TOWN OF GLASTONBURY

GL-2013-31

CCTV INSTALLATION @ GLASTONBURY HIGH SCHOOL

ADDENDUM #1

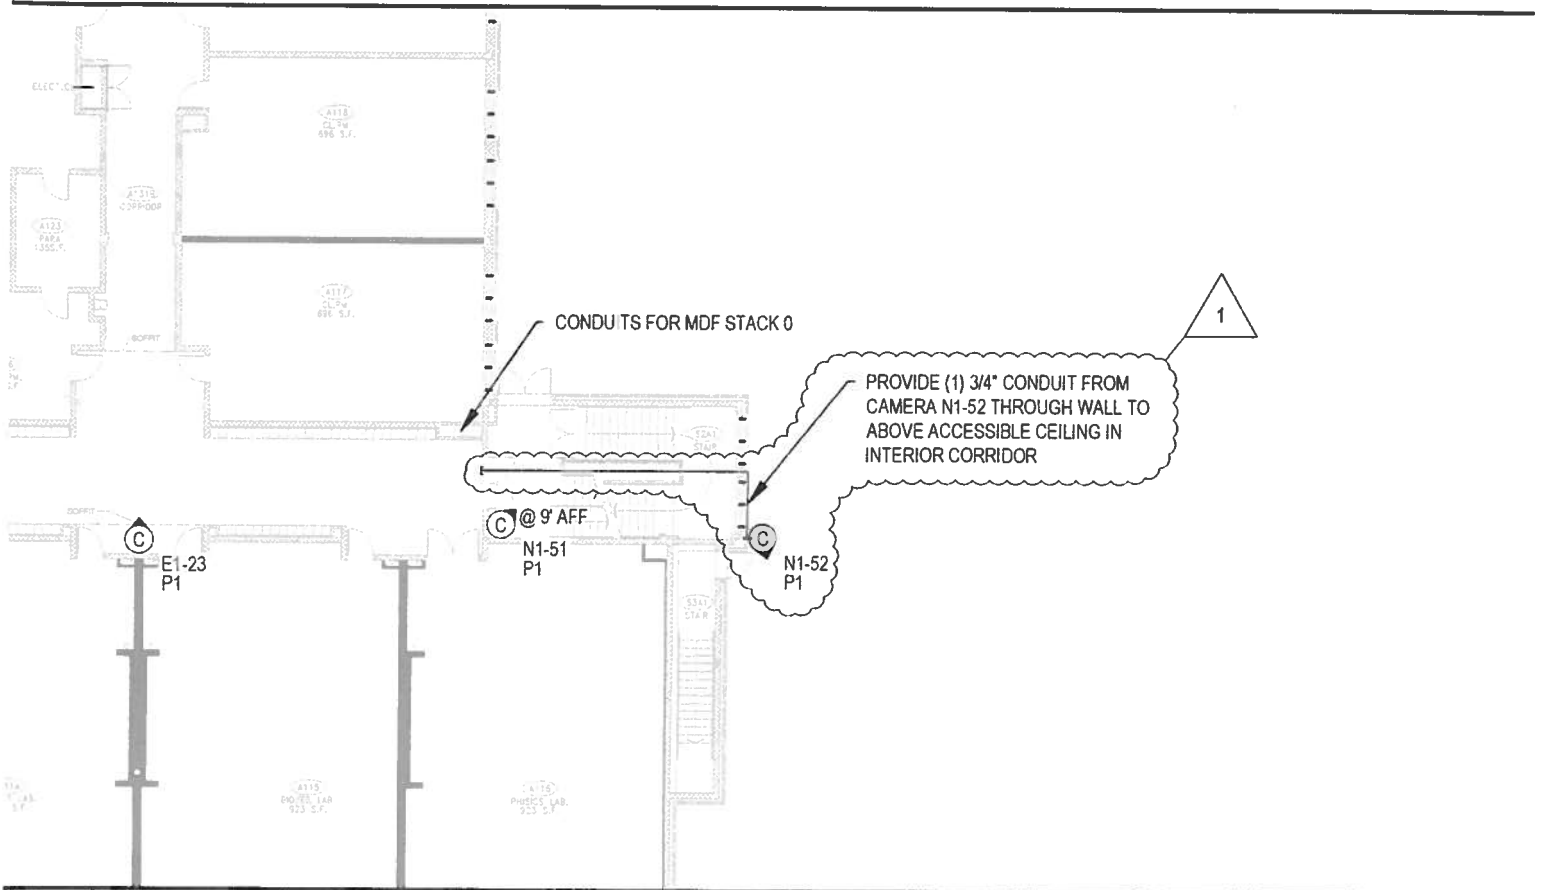
Drawing T201A – **ADD** (1) 3/4" conduit to be provided by contractor from camera N1-52 through exterior wall to above accessible ceiling in interior corridor. Refer to sketch T201A-1.

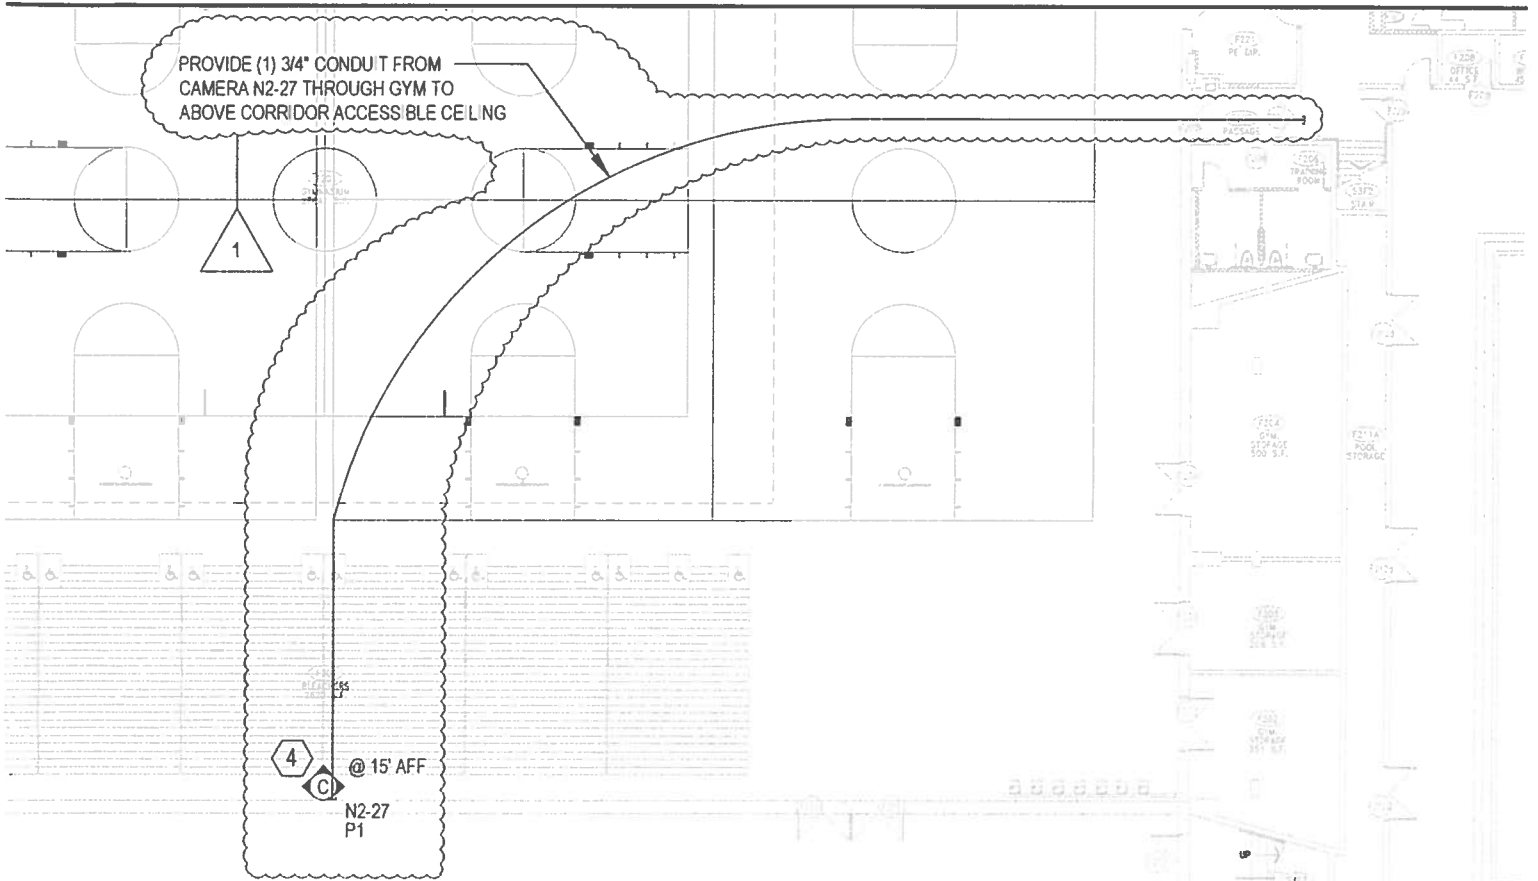
Drawing T202F – **ADD** (1) 3/4" conduit to be provided by contractor from camera N2-27 through gym to above accessible ceiling in corridor. Refer to sketch T202F-1.
